## STAFF REPORT

### SPECIAL EXCEPTION AMENDMENT APPLICATION SEA 84-V-035

**APPLICANT:** Huntwood, L. L. C.

**PROPOSAL:** Amend the previously approved special exception to allow a 1-story drive-in bank adjacent to the existing 8-story, 98-foot tall office building and an increase in the land area covered by the special exception

**CONCEPTUAL LANDSCAPE PLAN**

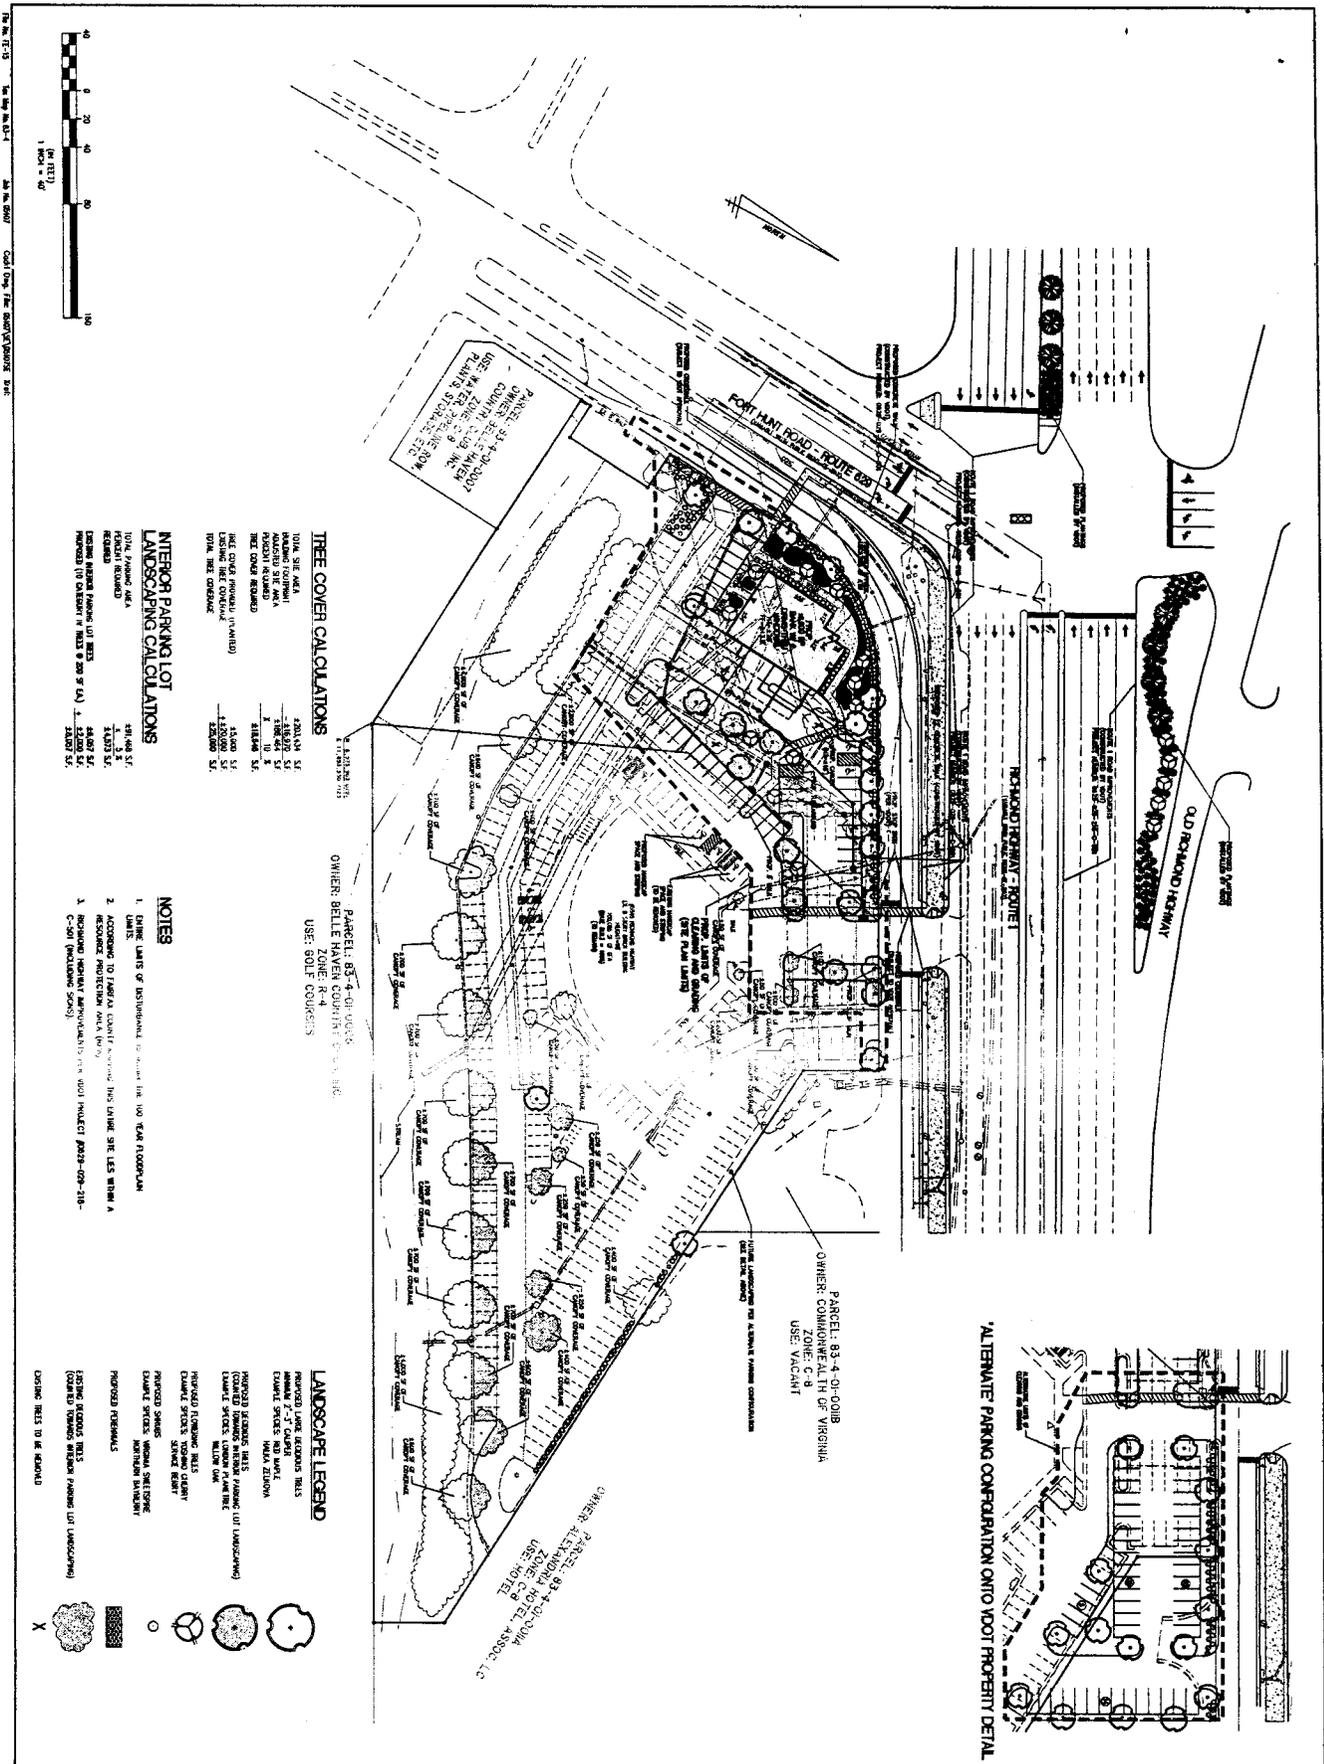
The comments of the Urban Forestry Branch recommend that additional trees be planted within the RPA. A proposed development condition requires that five additional trees be planted within the RPA.

10. If Parcel 11B is included in the site plan for the initial construction of the proposed drive-in bank, it shall landscaped as shown on the inset on Sheets 4 and 6 of the SEA Plat. However, if Parcel 11B is not included in the site plan, prior to the issuance of the Non-residential Use Permit (Non-RUP) for the drive-in bank, the six parking spaces, which back into the travel aisle from the entrance to the site from the service drive shall be replaced with a landscaped island.
